ADDENDUM NO. 1 TO PROJECT NO. 44601

**CONSTRUCTION WORK, HVAC WORK, PLUMBING WORK, ELECTRICAL WORK
CONSTRUCT NEW TRAINING BUILDING
UPSTATE CORRECTIONAL FACILITY
BARE HILL ROAD
MALONE, NY**

July 28, 2015

10 BENCH DETAIL

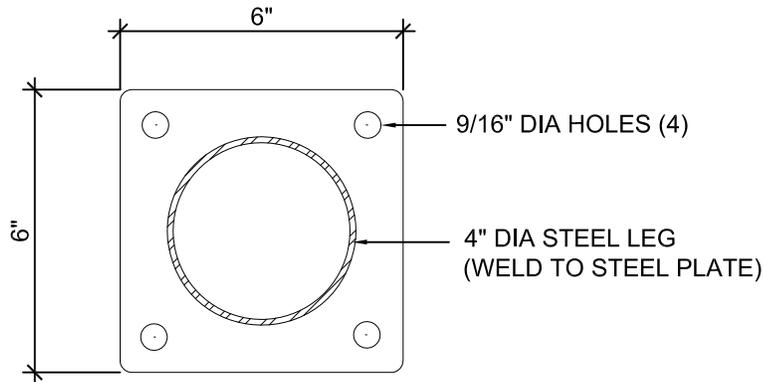
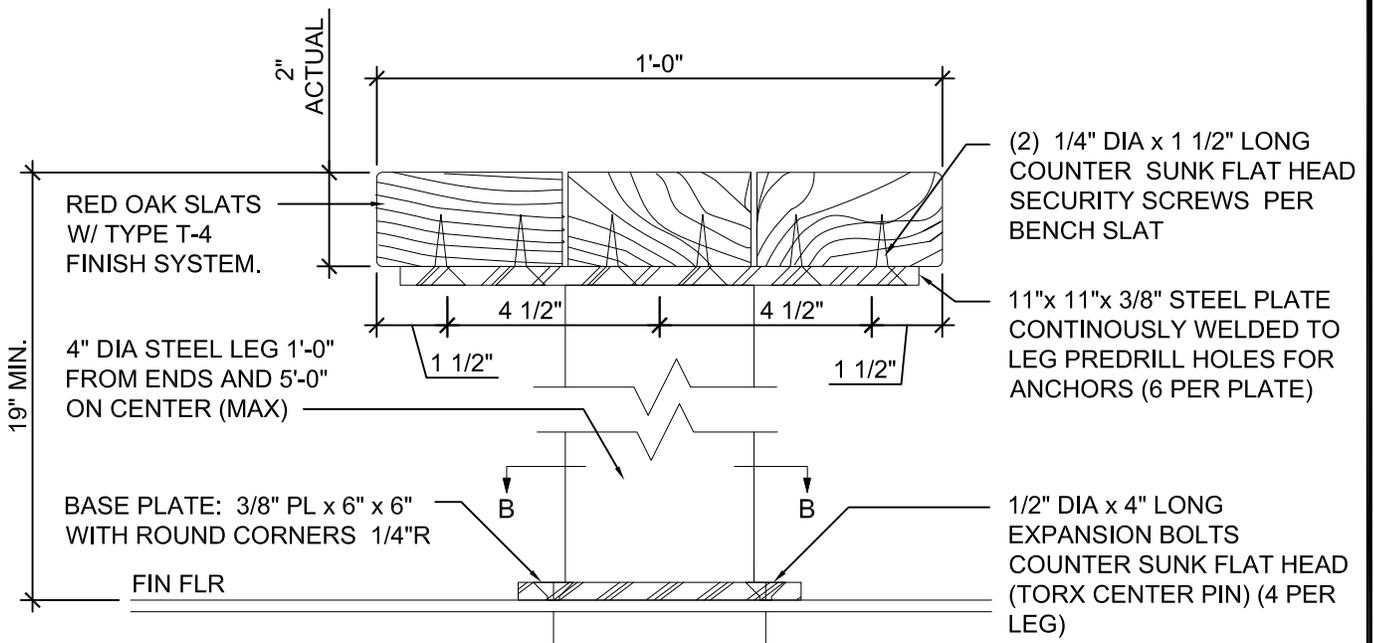
7. DRAWING NO. G-001 – TITLE SHEET: Add FBO (Furnished BY Others) to the list of ABBREVIATIONS.
8. DRAWING NO. A-101, CONSTRUCTION NOTES: Change Note 11 to read:
“PRE-FINISHED METAL LOCKER (FBO), REFER TO DETAIL 6/A603.”
9. DRAWING NO. A-603, DETAIL 10 - LOCKER DETAIL: Add the following note the detail:
“Lockers shall be ‘Furnished by Others’ (FBO), installed by Contractor.”
10. ADDENDUM DRAWING A-600.1:
 - a. Add drawing A-600.1, titled “LOCKER ROOM BENCH DETAIL” and is noted “ADDENDUM NO. 1” is attached to this Addendum and becomes part of the bid documents.
